Addendum / Addenda

No./N^o
2

Project Description / Description de projet M10-Electrical Vault Ventilation		
Solicitation No./ No de sollicitation 14-22068	Project No./N ^o de projet 4021	W.O. No./N ^o d'ordre de travail A1-004018-02
Project Engineer / Ingénieur de projet Josh Hale (Stantec)		Date November 12,2014
<p>Notice: This addendum shall form part of the tender documents and all conditions shall apply and be read in conjunction with the original plans and specifications.</p>		<p>Nota: Cet addenda fait partie intégrale des dossiers d'appel d'offres; toutes les conditions énoncées doivent être lues et appliquées en conjonction avec les plans et les devis originaux.</p>

WALL OPENING INFILL - TYP. ELEVATION
 N.T.S.

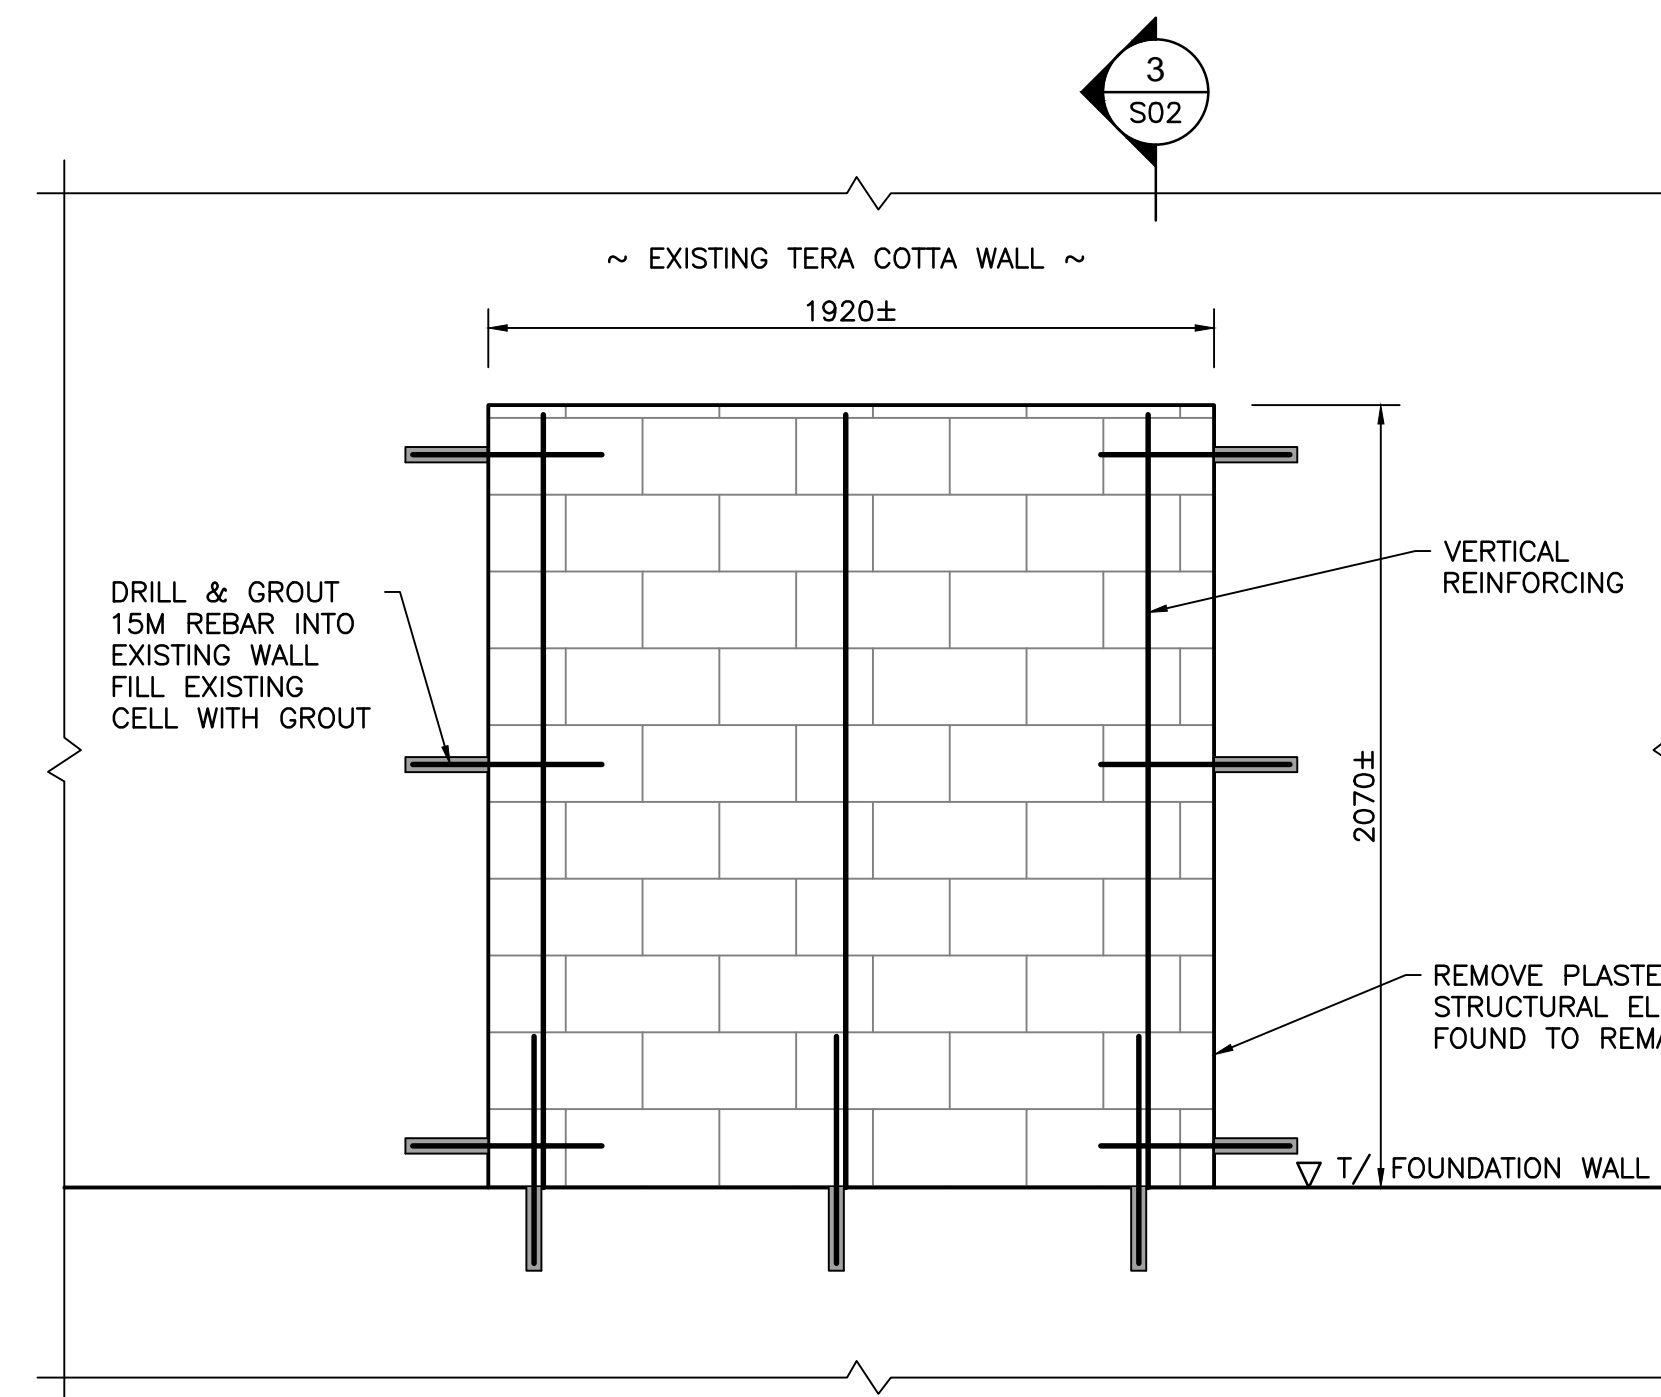
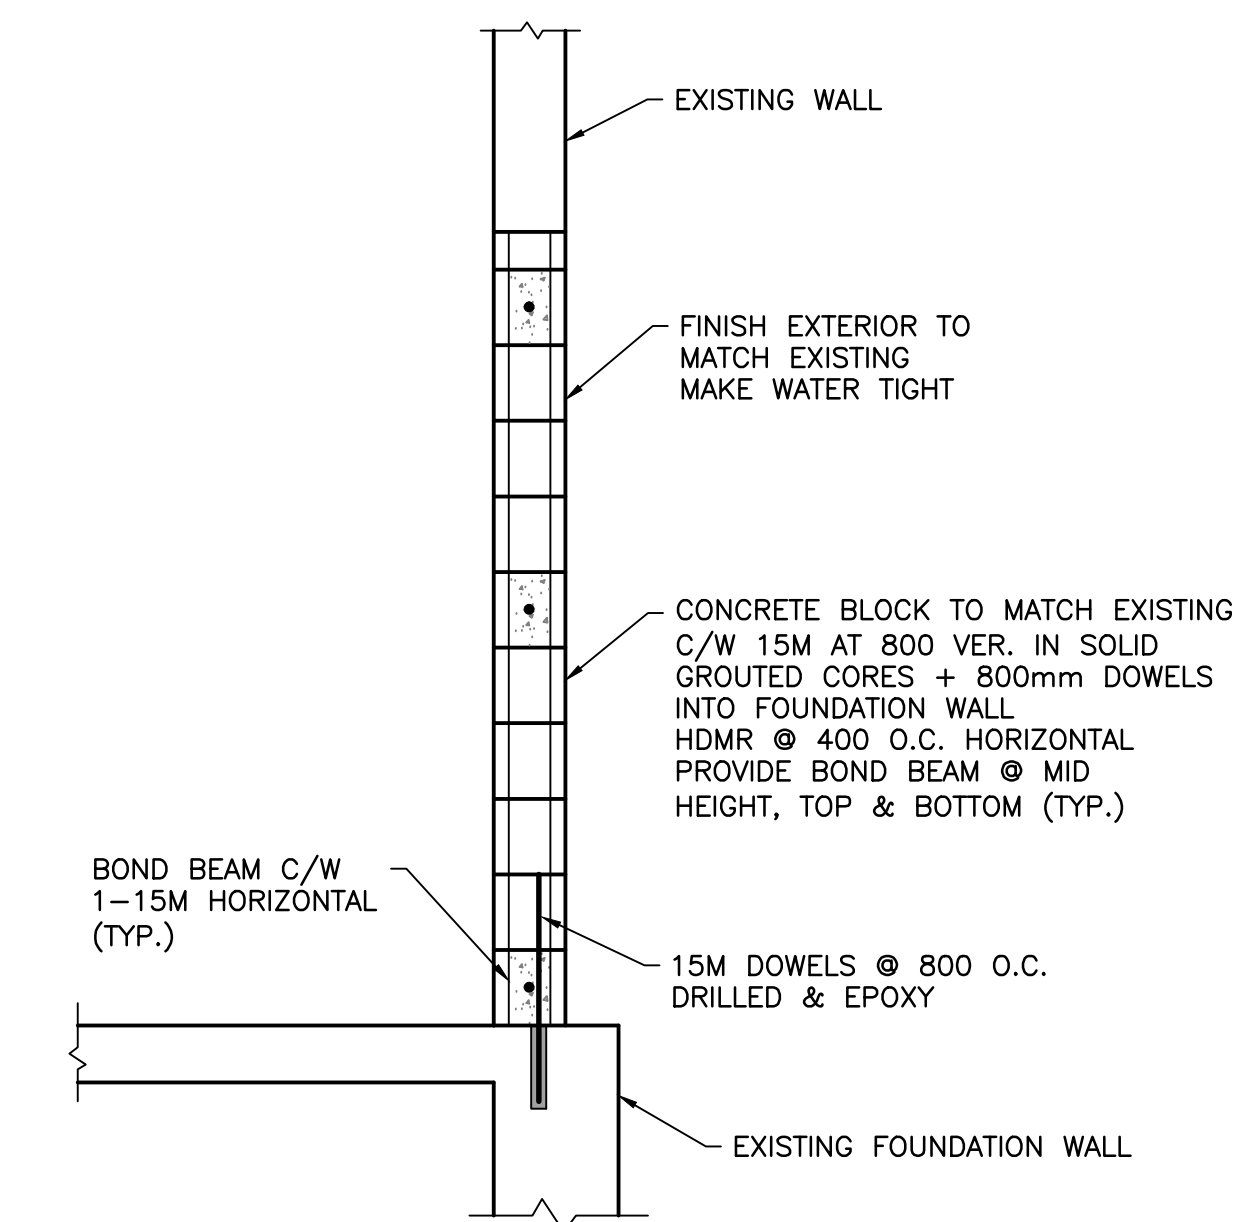
Question B: On SO2 - at the wall opening infill, the plaster archway is to be removed in order to achieve the installation of rebar dowels. Please confirm.

Answer: Confirmed. Drawings have been updated.

EXISTING SECOND FLOOR WALL SECTION
 N.T.S. (FROM RECORD DRAWING A3497 DATED DEC. 6, 1966)

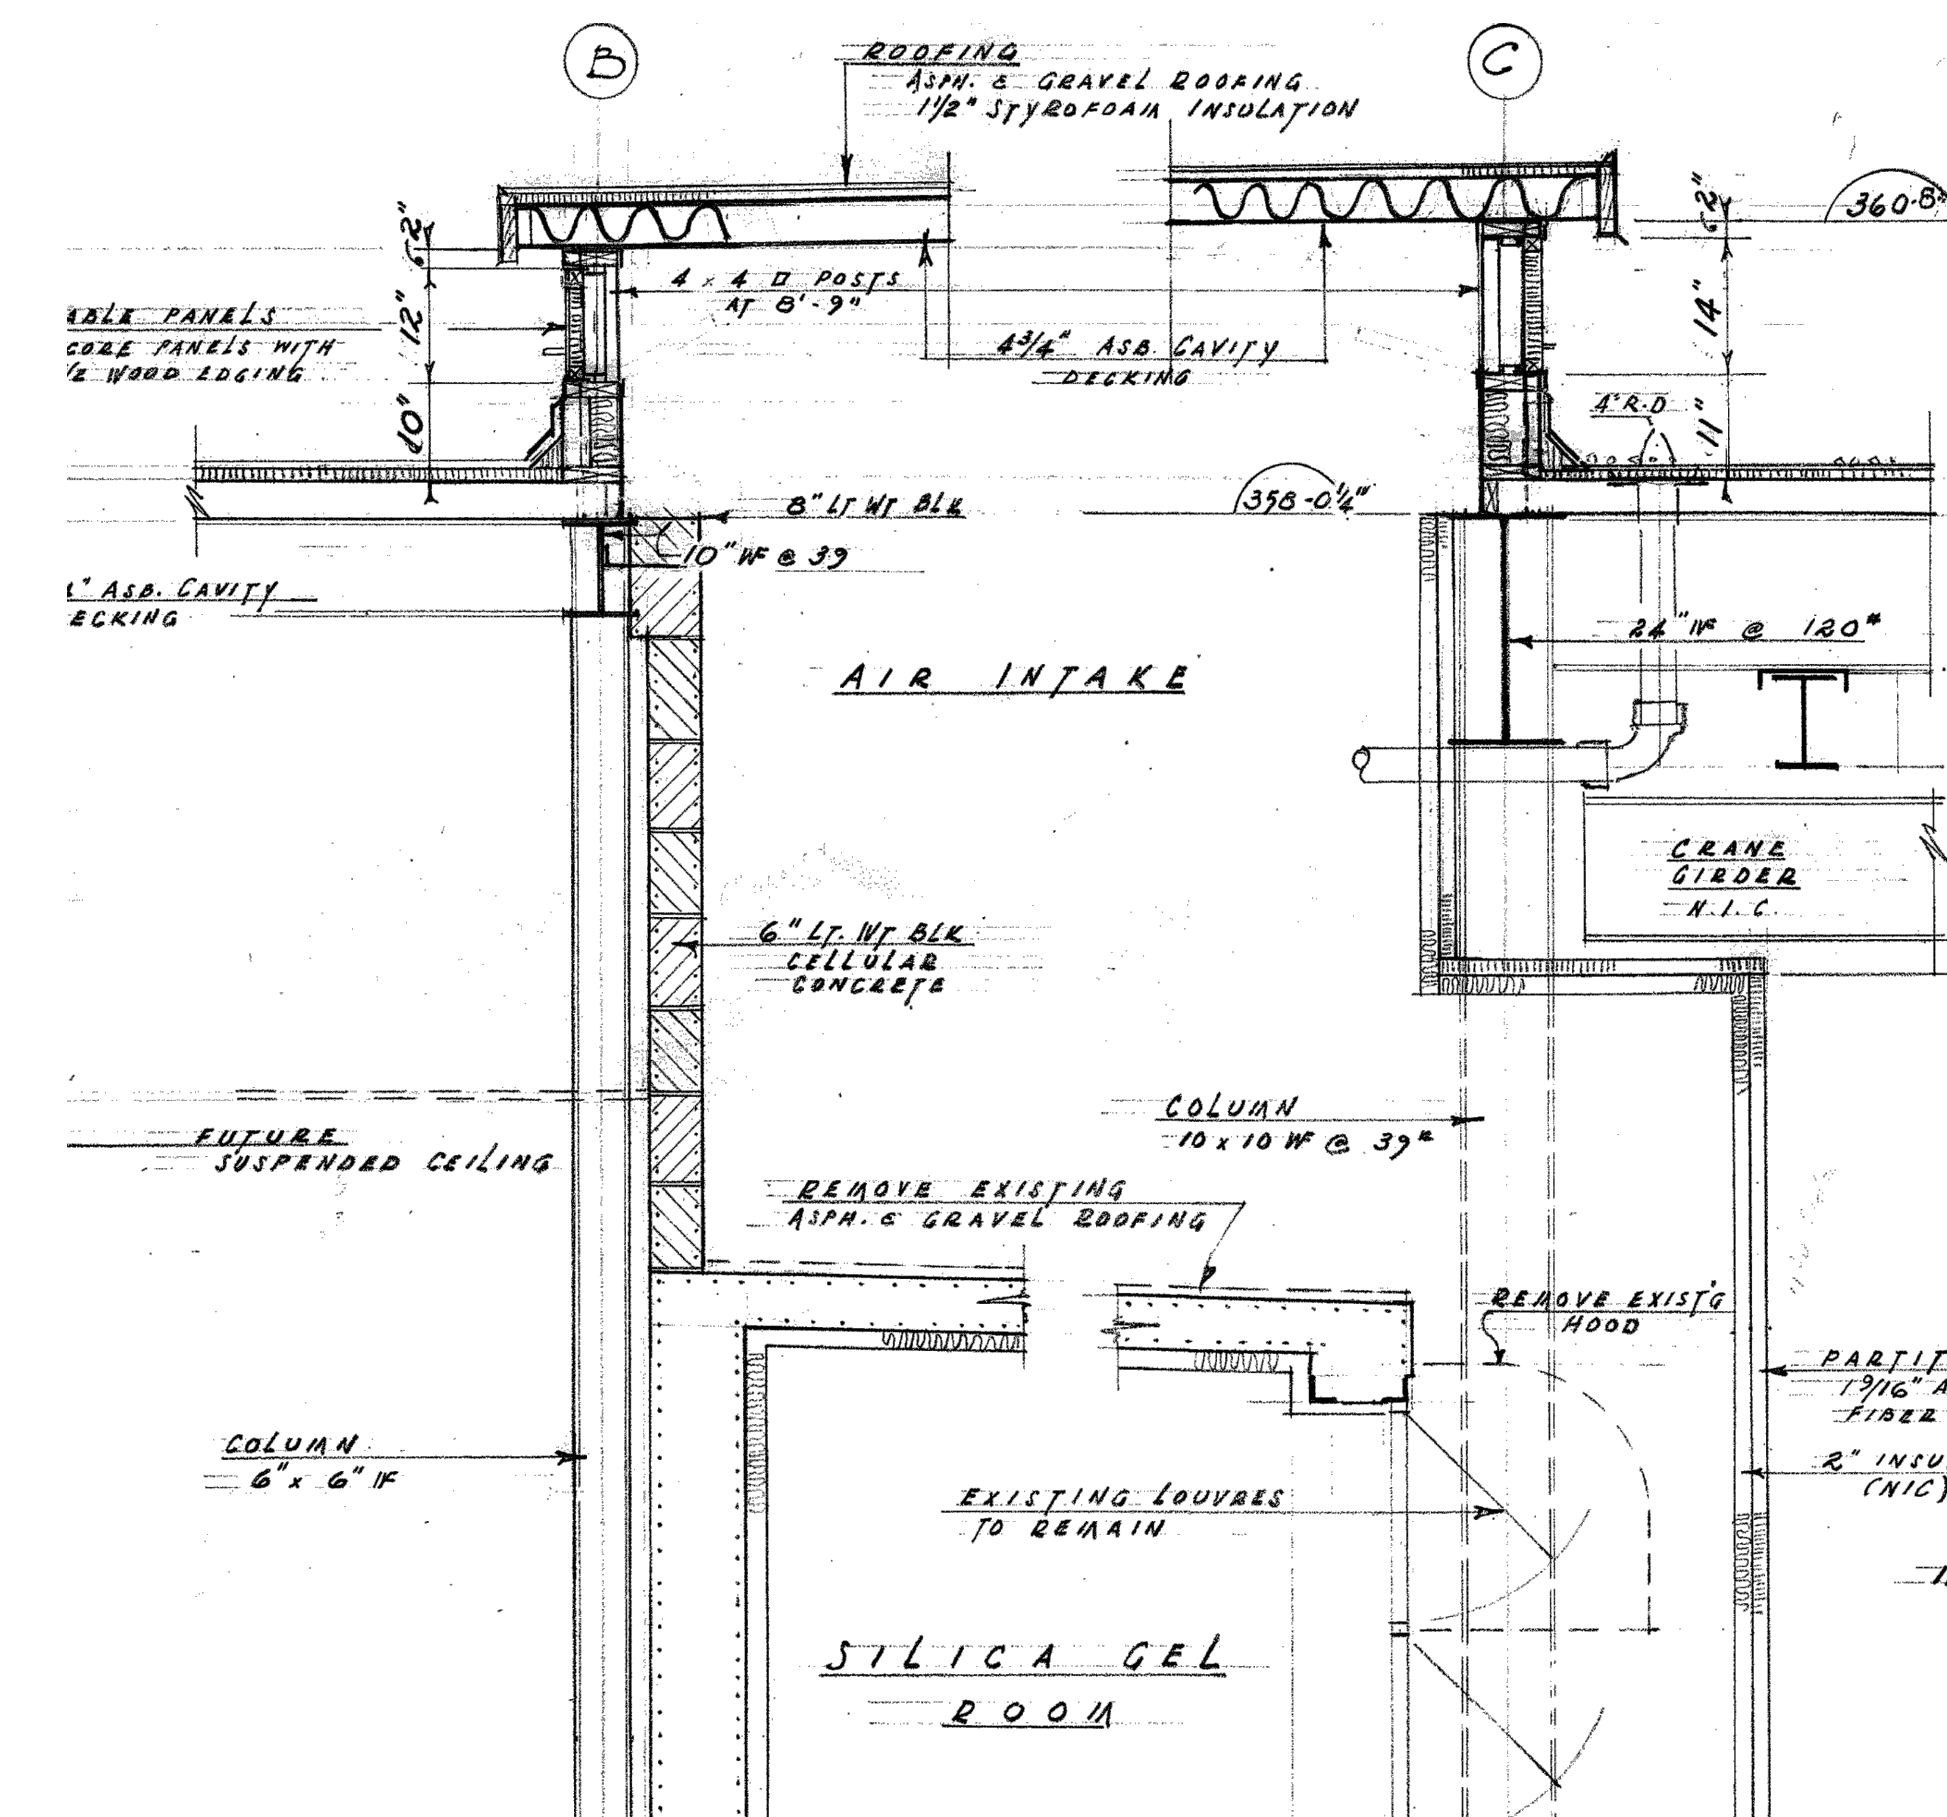
Question D: At roof level, in order to install the new C12 structural steel under the structural slab, the 1/4" transit panels will have to be removed in order to expose the slab. What is the intention to complete the work after the structural steel and the duct work is installed, do you wish these panels to be cut and adjusted to fit the new layout between the structural steel and the duct work. I suspect that these panels contain asbestos. Please clarify.

Answer: We have added a section to our drawings showing original (1950's) design drawings for the area in question, contractors will need to assess the roof construction. New, similar in appearance and function, or existing panels should be cut and adjusted to fit new layout between structural steel and duct work.
